ENGAGEMENT REPORT ADDENDUM

(Response to Submissions)

Julius Avenue Data Centre
SSD-80018208

Property at 6-8 Julius Avenue, North Ryde

Figure 3: Comparison of July 2025 and December 2025 Schemes

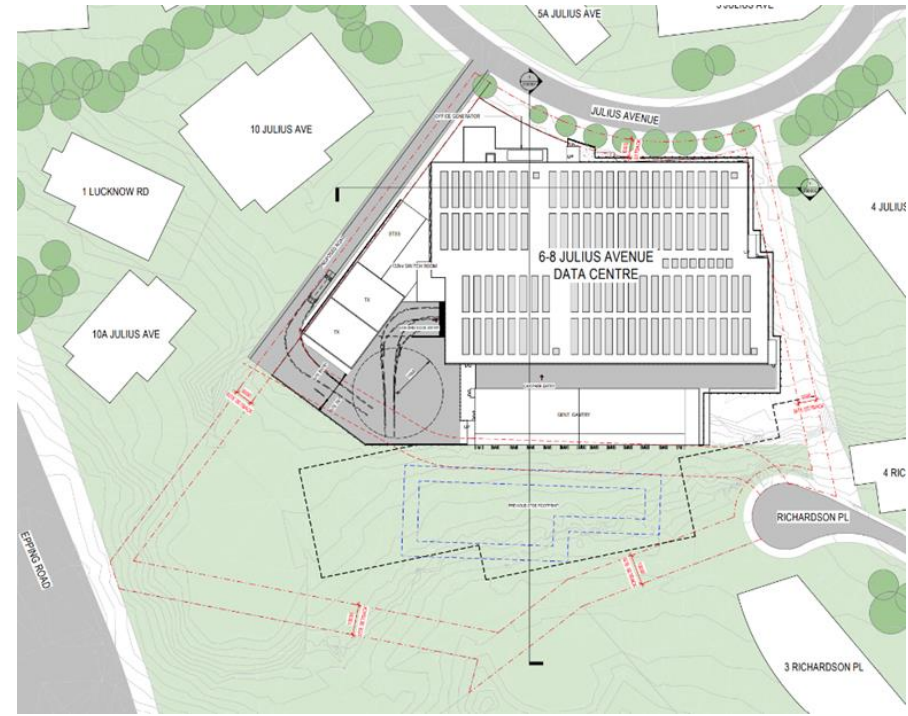
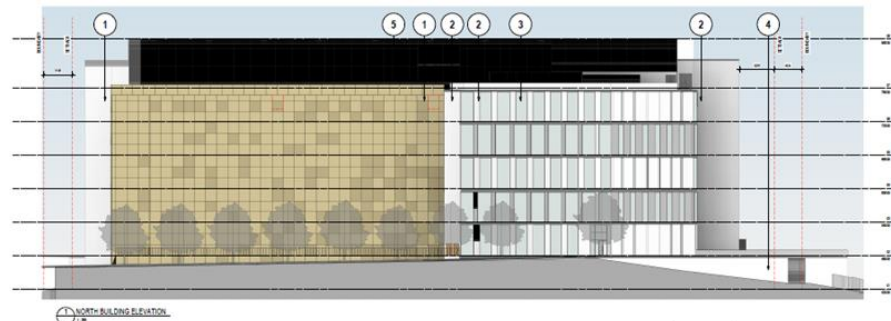
The following side-by-side images (refer **Figure 3**) provide a comparison of the schemes showing the reduction in the development footprint through the integrated Sub-Transmission Switching Station (STSS), as well as the decrease in height from the reduced capacity operation.

Site Plan - JULY 2025 SSDA Submission

Site Plan - DECEMBER 2025 Proposed amended design

July 2025 Scheme

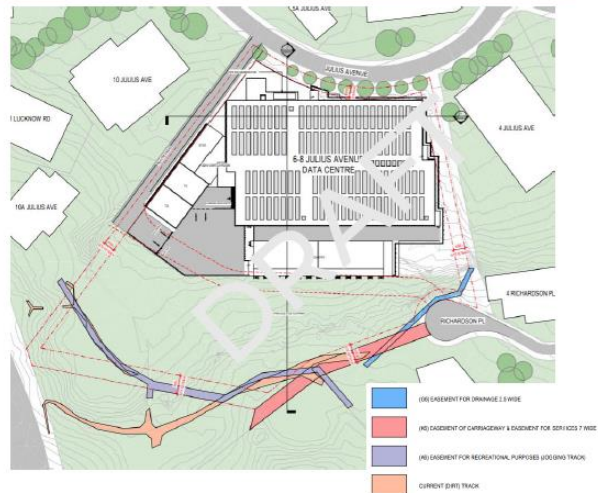
STSS is integrated into western side of the building (Blue dotted line: denotes former STSS footprint)

- Air cooled Data Centre changes configuration from previous water-cooled
- approx 34% reduction in IT load of Data Centre
- Scale of the proposed scheme has been reduced, including lower building heights
- Integrates smaller STSS to west side of the building
- Reconfiguration of proposal with removal of link road between Richardson Place and private road shared with 10 Julius Ave
- Addressing key elements including bushland retention, building bulk and scale, noise and visual impact

Artist Perspective

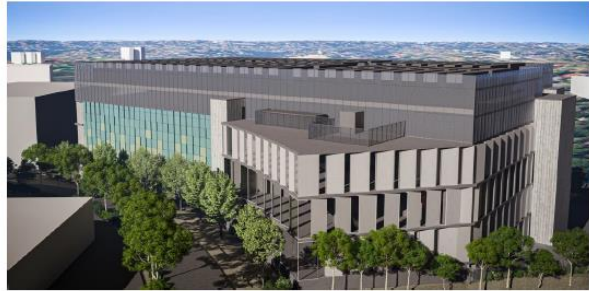
Original Scheme (July 2025)

Revised scheme (Work in Progress, December)
